**Kevin Mooney**  
Senior Project Manager  
Corporate Holdings, GE Aerospace

1 Plastics Ave.  
Pittsfield, MA 01201

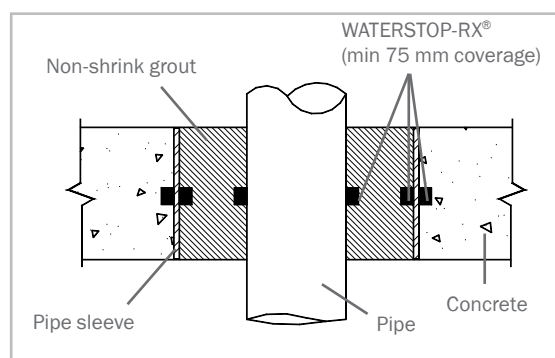
As-Built Markups of the Temporary Spillway Crack/Void Repair Plan Set
